**State of Alaska  
Department of Fish and Game  
Sportfish Division**

**Nomination Form  
Anadromous Waters Catalog**

Anadromous Waters Catalog Number of Water Body 114-32-10560

## Eight Fathom Bight Uncataloged Stream 2

Figure 4.—Eight Fathom Bight Uncataloged Stream 2 Addition map.

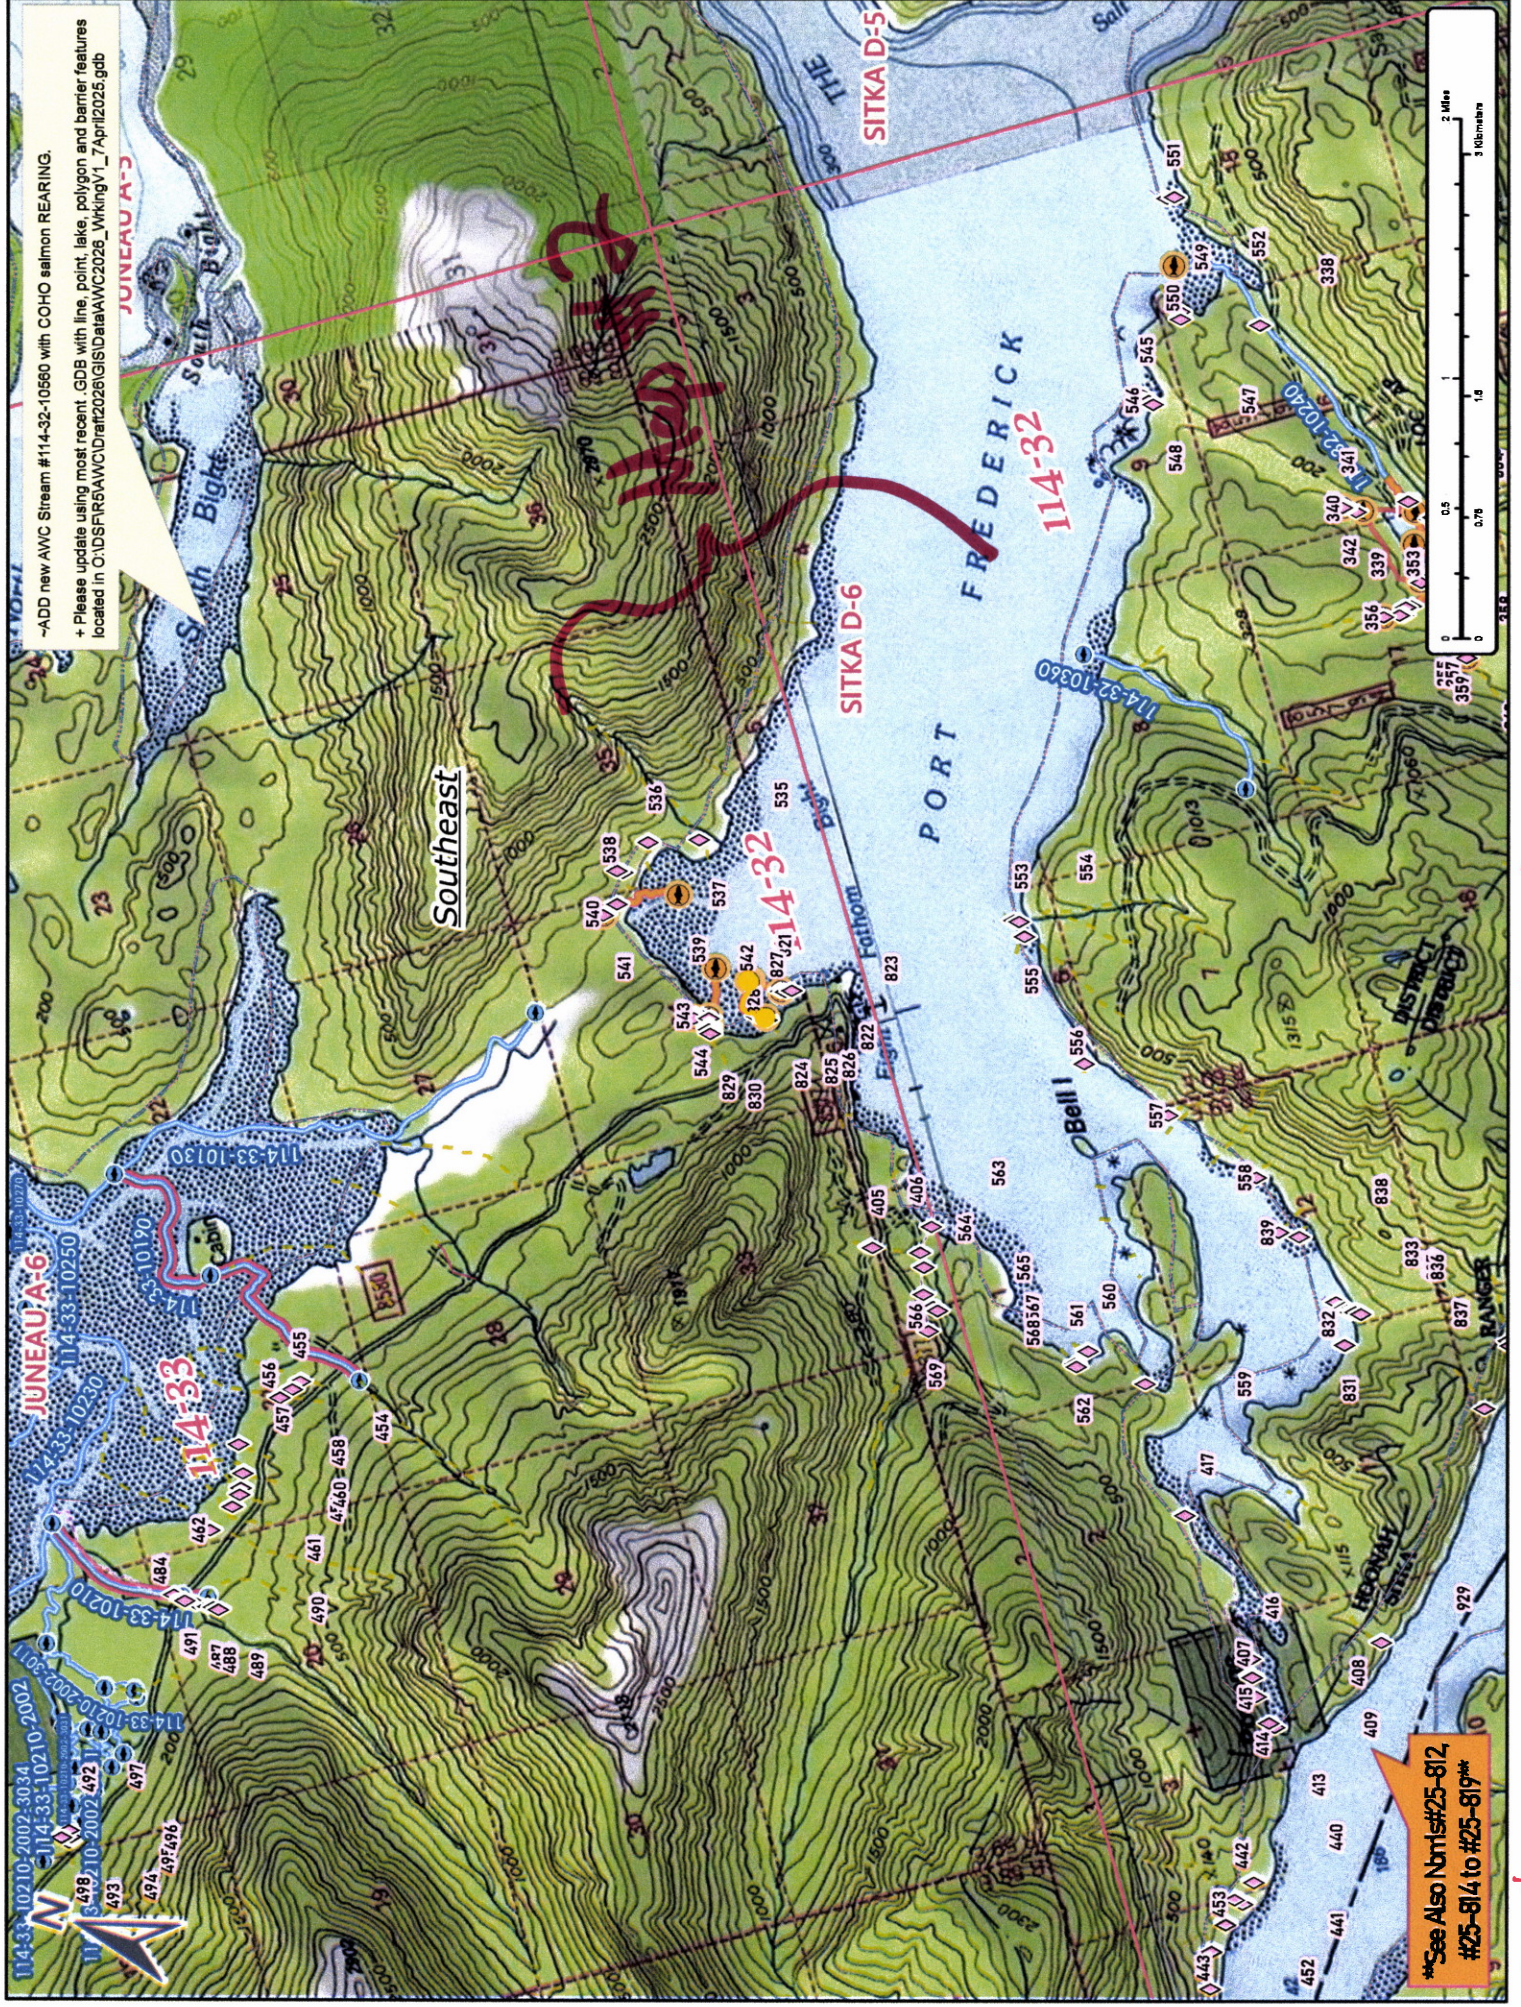
**Recommendations:** Add this uncataloged stream into the anadromous waters catalog for rearing coho salmon from its mouth in the intertidal up to waypoint 825 (Figure 4).
